UNITED STATES
DEPARTMENT OF THE INTERIOR
BUREAU OF LAND MANAGEMENT

FORM APPROVED
OMB NO. 1004-0135
Expires: July 31, 2010**SUNDRY NOTICES AND REPORTS ON WELLS**
*Do not use this form for proposals to drill or to re-enter an abandoned well. Use form 3160-3 (APD) for such proposals.***SUBMIT IN TRIPLICATE - Other instructions on reverse side.**

1. Type of Well <input checked="" type="checkbox"/> Oil Well <input type="checkbox"/> Gas Well <input type="checkbox"/> Other	2. Name of Operator BURNETT OIL CO., INC.	Contact: LESLIE M GARVIS E-Mail: lgarvis@burnettoil.com	5. Lease Serial No. NMLC029338A
3a. Address BURNETT PLAZA - SUITE 1500 801 CHERRY STREET FORT WORTH, TX 76102	3b. Phone No. (include area code) 817-332-5081, 817-332-6102	10. Field and Pool, or Exploratory. CEDAR LAKE GLORIETA YESO	6. If Indian, Allottee or Tribe Name
4. Location of Well, (Footage, Sec., T., R., M., or Survey Description) Sec 14 T17S R30E 330FSL 2230FWL		11. County or Parish, and State EDDY COUNTY COUNTY, NM	7. If Unit or CA/Agreement, Name and/or No.
8. Well Name and No. GISSLER A 25			9. API Well No. 30-015-34021

DRILLING PLAN
Gissler A 25 Deepening

FIELD: LOCO HILLS PADDOCK WELL NAME: Gissler A.25 Proposed In Red FORMATION: Yeso
UNIT: N SEC: 14 GL: 3689' STATUS: Oil Well
TWNSHP/RANGE: T17S R30E COUNTY: EDDY KB: 3700' API NO: 30-015-34021
LOCATION: 330' FNL 2330' FWL STATE: NM DF: LAT:
LONG:

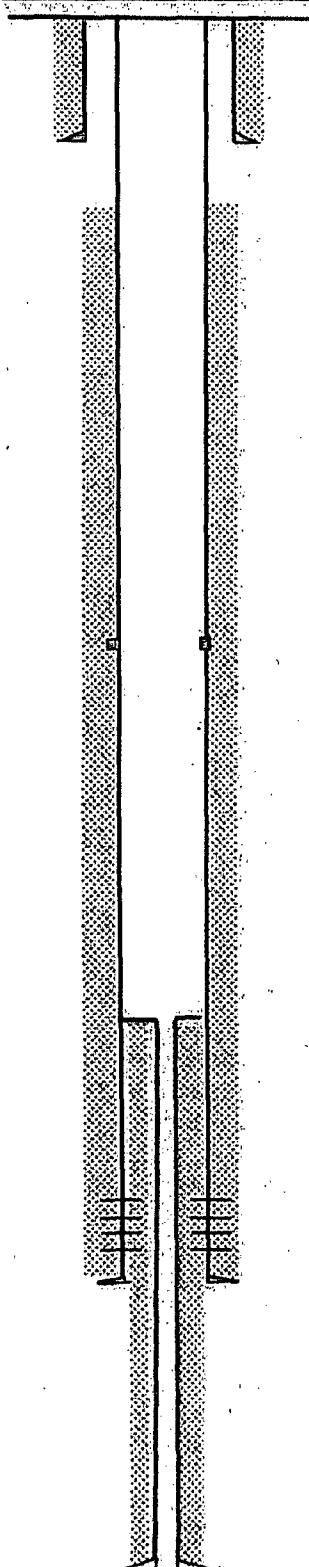
5. BOP to be tested to **2000 psi** based on BHP expected. **In the case where the only BOP installed is an annular preventer, it shall be tested to a minimum of 2000 psi (which may require upgrading to 3M or 5M annular).**

6. Variance for stand-off of less than 0.422" is approved due to NMOCD classifying the formations in this area as the Yeso group.
7. Cement on liner shall tie back to liner top, if this is not achieved contact appropriate BLM office. When plugged, cement plug will be required across this tie back and across squeezed perforations.

8. Test casing as per Onshore Order 2.III.B.1.h.
9. Subsequent sundry detailing work and current well test data are to be submitted when work is complete.
